<b>Wulfsberg Electronics</b> <i>A Chelton Group Company</i>				
<b>APPROVALS</b>	<b>DATE</b>			<b>TITLE:</b>		
DRAWN	R. DuRall	11/04/04	<b>SERVICE BULLETIN WSB IDU-III-14</b> <b>(AIU-1 REPLACEMENT)</b>			
CHECKED	D. Boston	11/04/04				
PRODUCT MANAGER	---	---				
ENGINEER	R. DuRall	11/04/04	SIZE	CAGE CODE	DWG NO.	REV
ISSUED	V. Wallace	11/04/04	<b>A</b>	<b>1B7G3</b>	<b>150-045026</b>	<b>B</b>
<b>Typed signatures indicate approval. Handwritten signature approval of this document is on file at Wulfsberg Electronics, Prescott, Arizona.</b>			SCALE: NONE		DO NOT SCALE DRAWING

**BULLETIN NUMBER:** WSB IDU-III-14 Revision B

This document allows the replacement of the AIU-1 P/N 453-7000, Rev B or earlier with AIU-1 P/N 453-7000, Rev C (New) or Rev B, Mod 2 (Modified).

**Figure 2. AIU Maintenance Program Window**

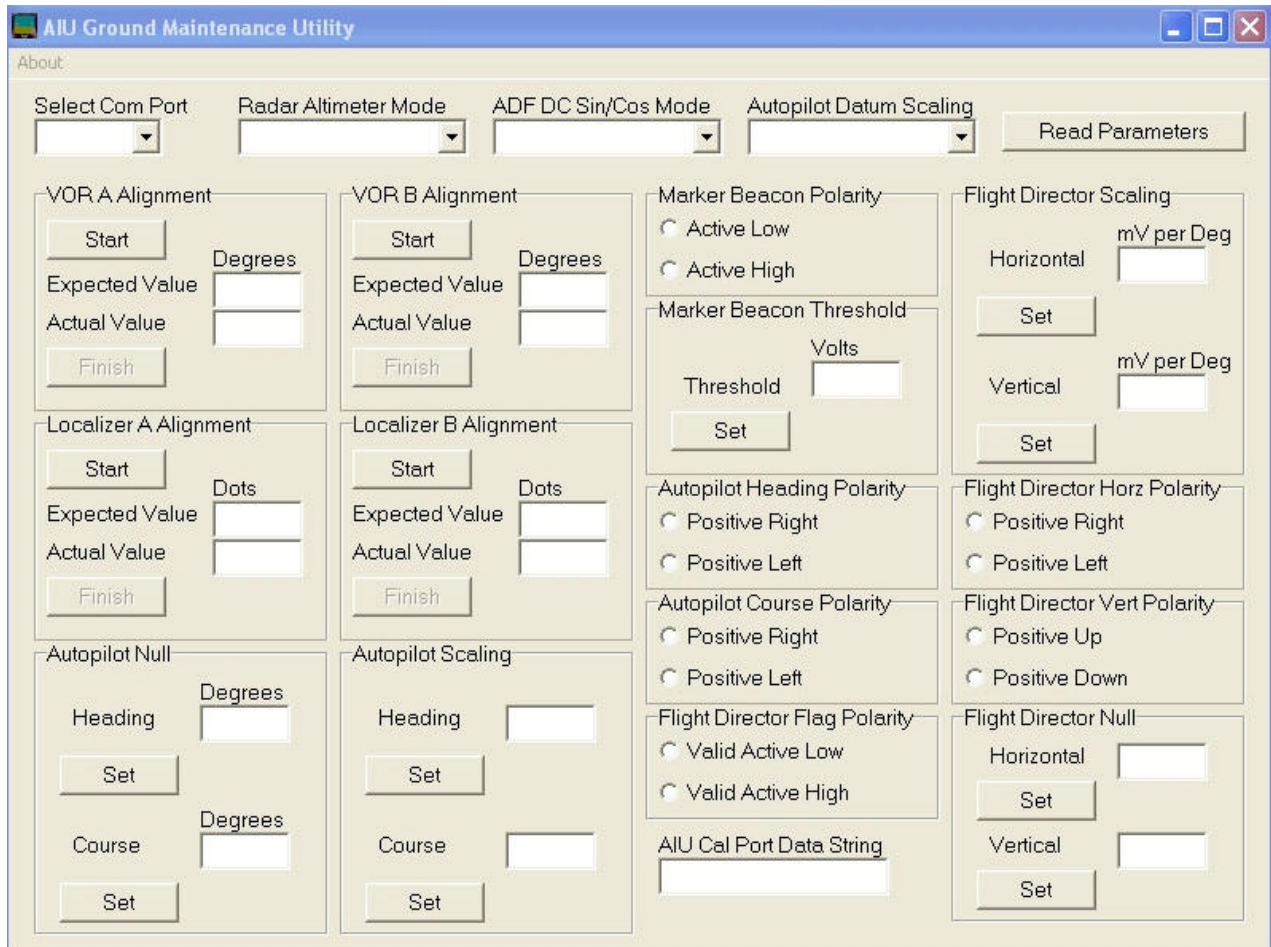
5. Select the appropriate Com port and press the “Read Parameters” button on the AIU Maintenance program window and note all of the readings on the last page of this Service Bulletin (see Figure 2).

1. Apply external power to the aircraft.
2. Apply power to the EFIS system and allow the EFIS to operate normally.
3. Activate the AIU Maintenance program on the Laptop computer.
4. Connect the 9-pin serial cable between the Laptop computer and the AIU Maintenance port on the aircraft.
5. Program the AIU with the data noted in Step 5 of the Modification Procedures section except for the VOR and Localizer alignments.
